工程指示 / 要求簡箋(E.I.)

工程指示編號：EI / 3580 / 21

工程名稱：亞皆老街中電

工程項目：後裝窗 地盤用玻璃 B.M. (T1-T3: 1-21/F) (90 件) 磨砂玻璃

後裝窗

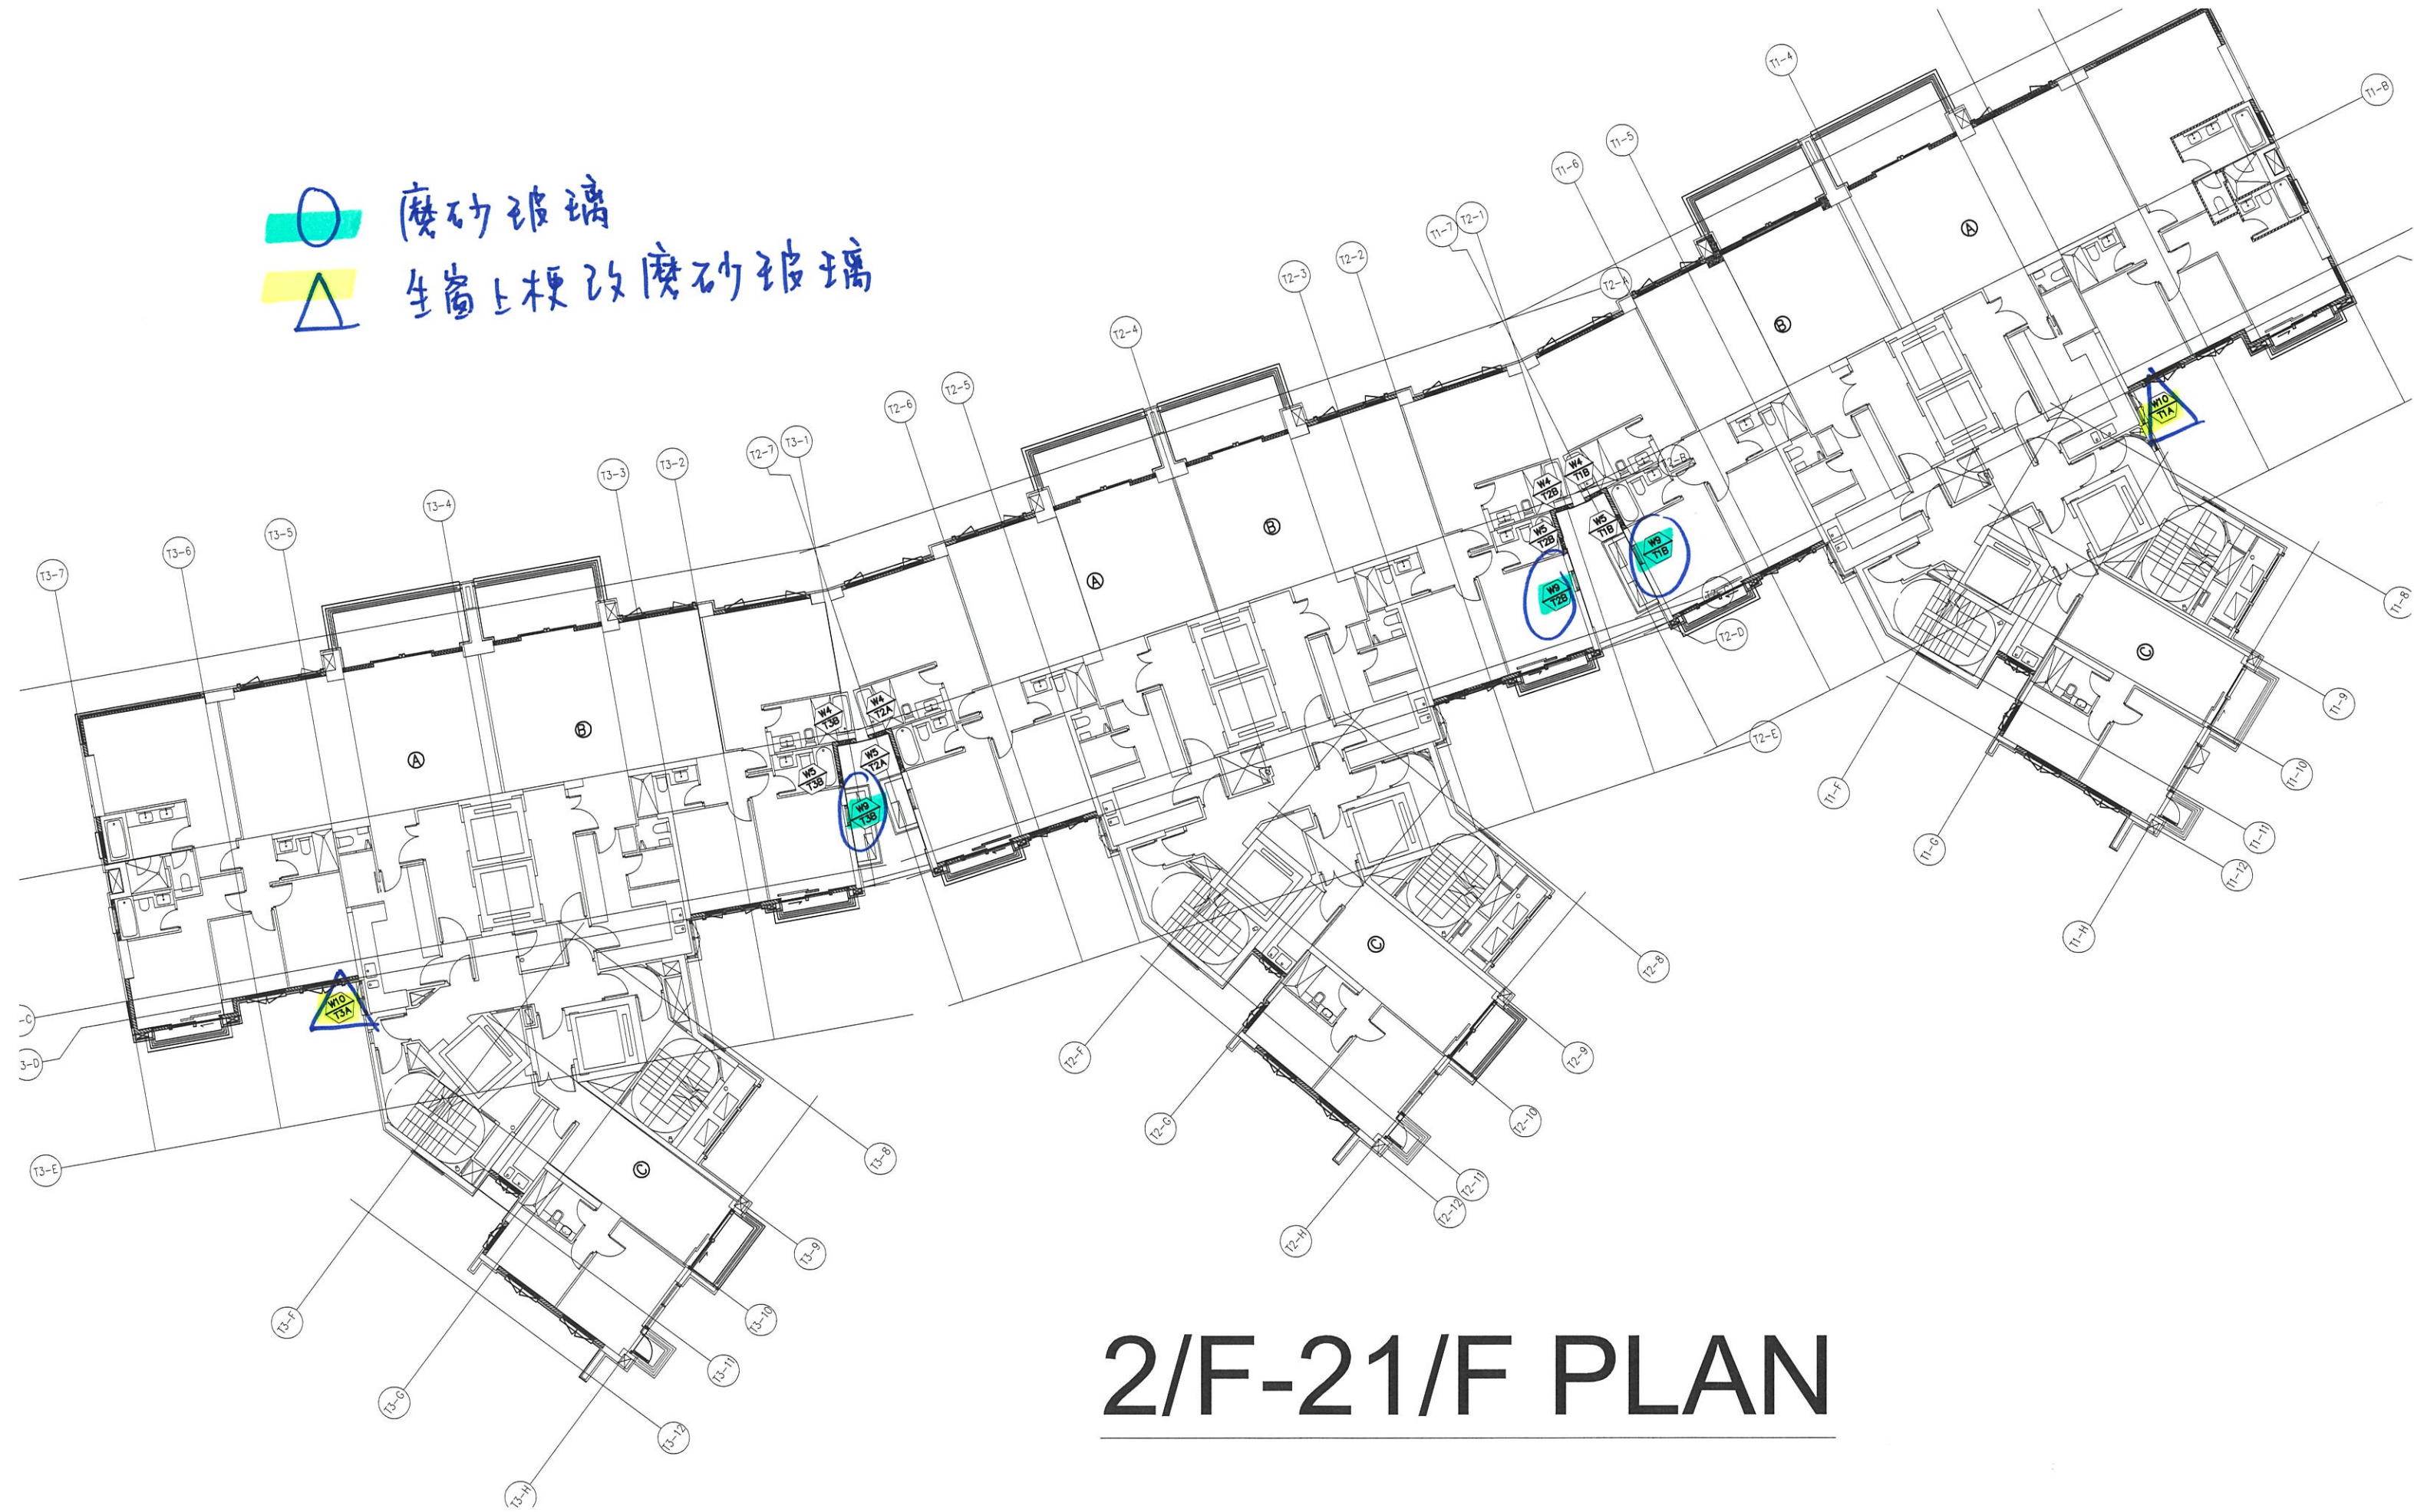
因則師要求部分後裝窗改為磨砂玻璃 (原 EI3182)，請按 B.M. 訂購 T1-T3: 1-21/F 磨砂玻璃 (共 90 件) (T1/T3: 各 36 件. T2: 18 件) 直送地盤。 T3 優先生產。 *分座包箱*

○ 磨砂玻璃

△ 主窗上框改磨砂玻璃

○ 磨砂玻璃
△ 生窗上框改磨砂玻璃

FIRST FLOOR PLAN
(1/F)

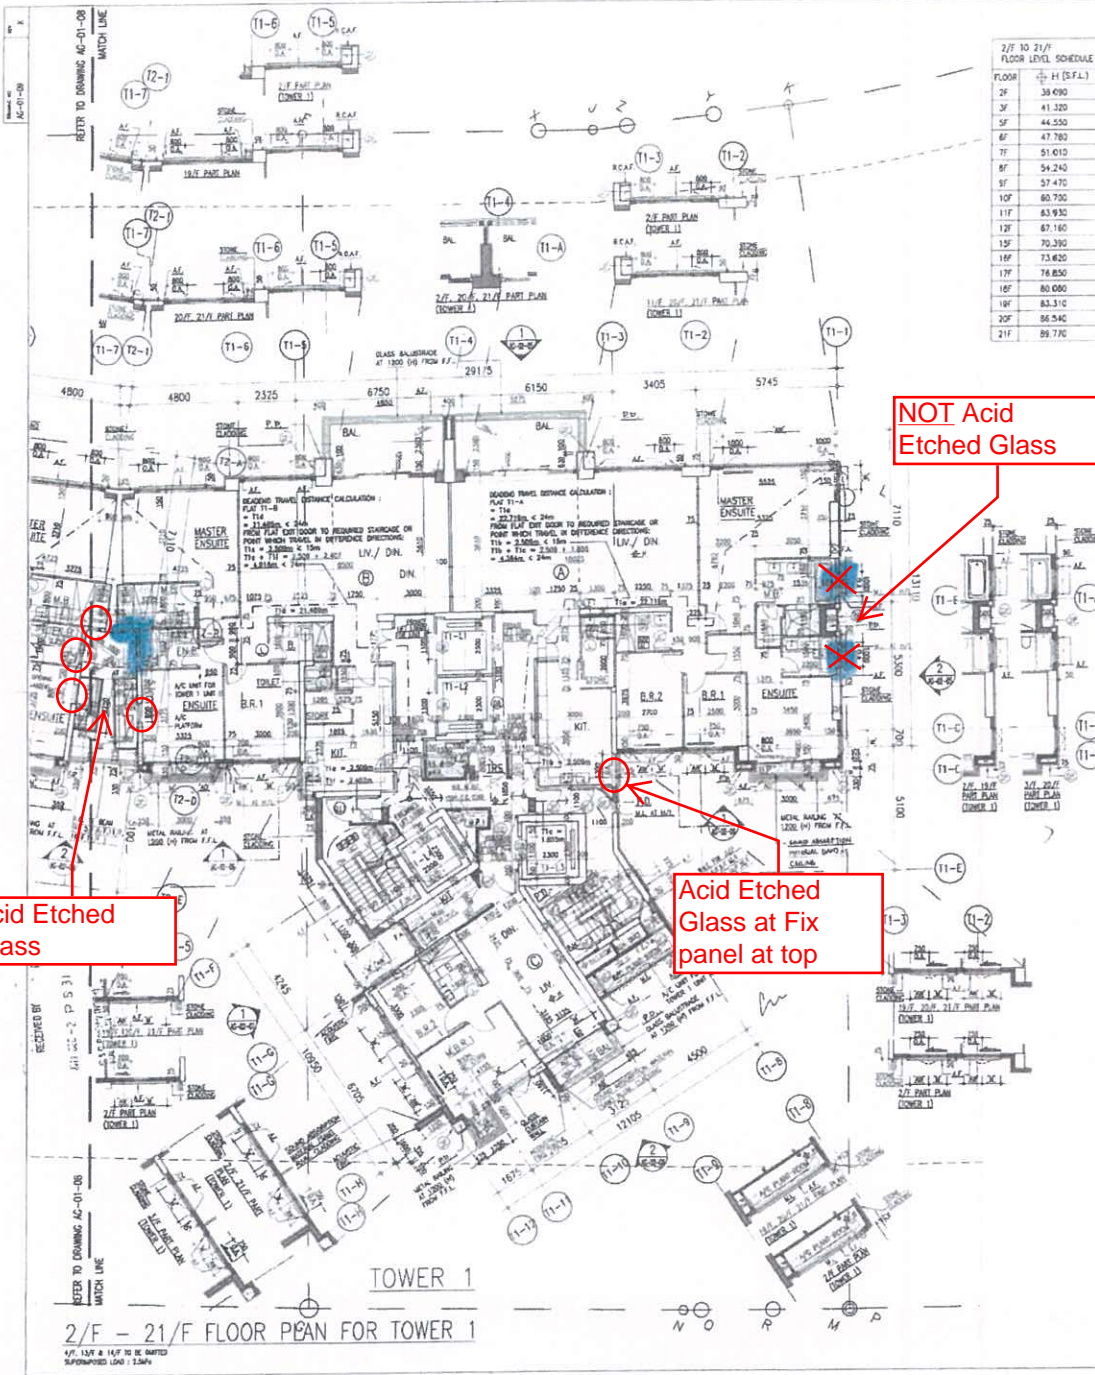
Please note that the location plan of acid etched glass to be used attached in your submission is INCORRECT. Please refer to attached markup for your further action. An updated location plan shall be attached to this submission for our approval.

NOT Acid Etched Glass

NOT Acid Etched Glass

Acid Etched Glass at Fix panel at top

Acid Etched Glass

Acid Etched Glass

Acid Etched Glass at Fix panel at top

22th FLOOR PLAN
(SHEET 2)

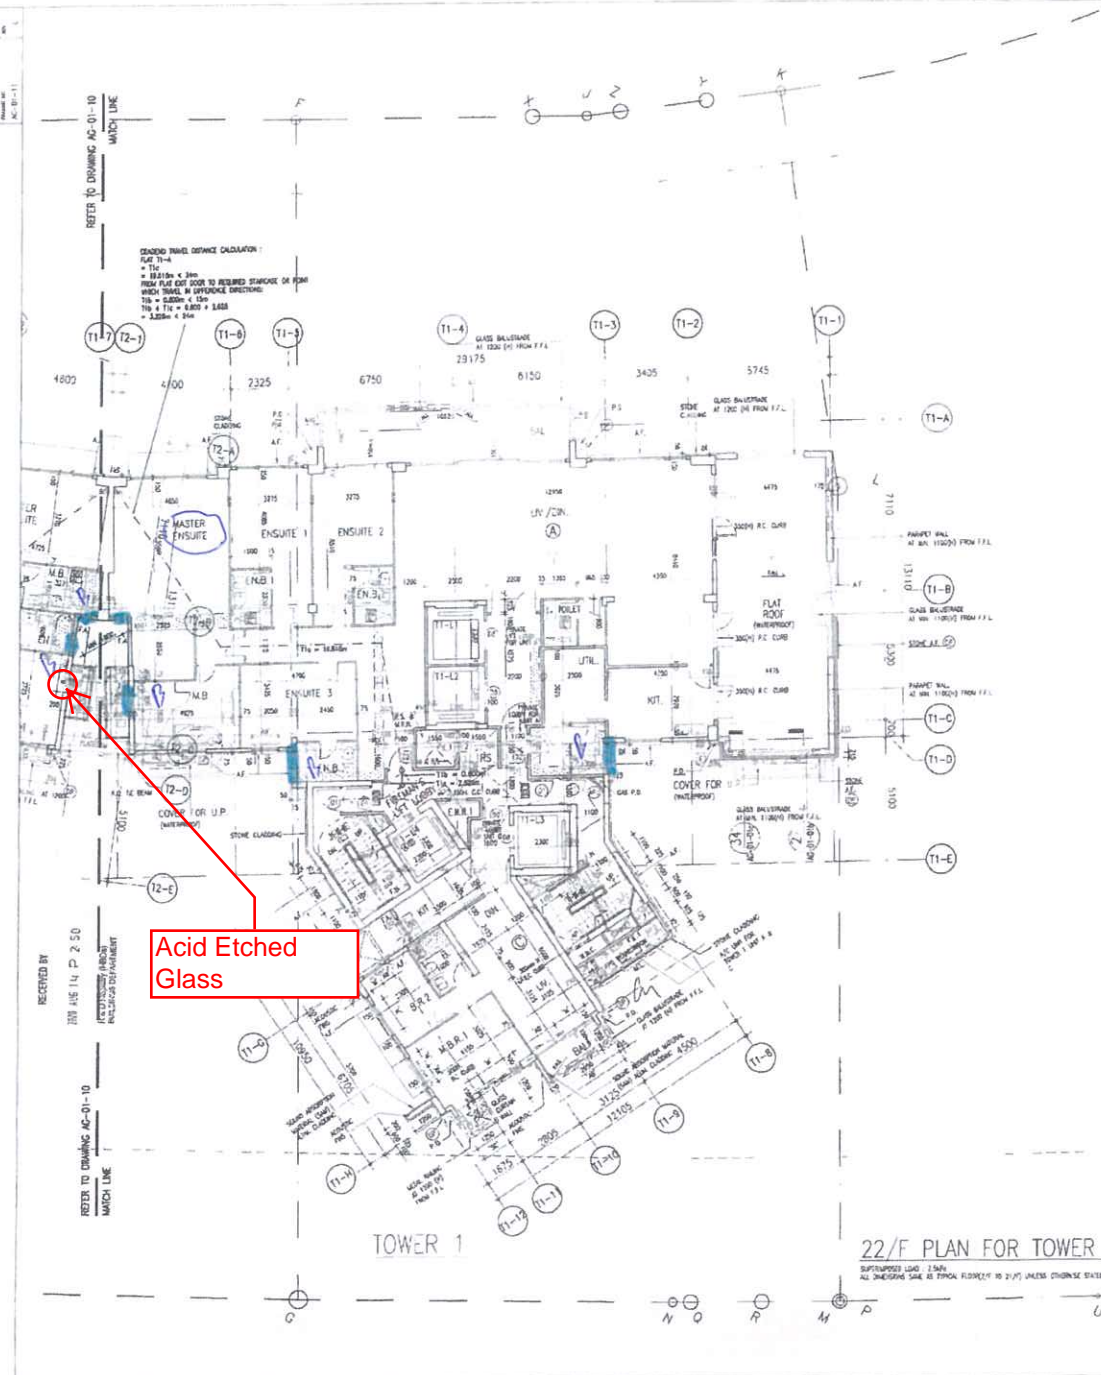
Acid Etched Glass
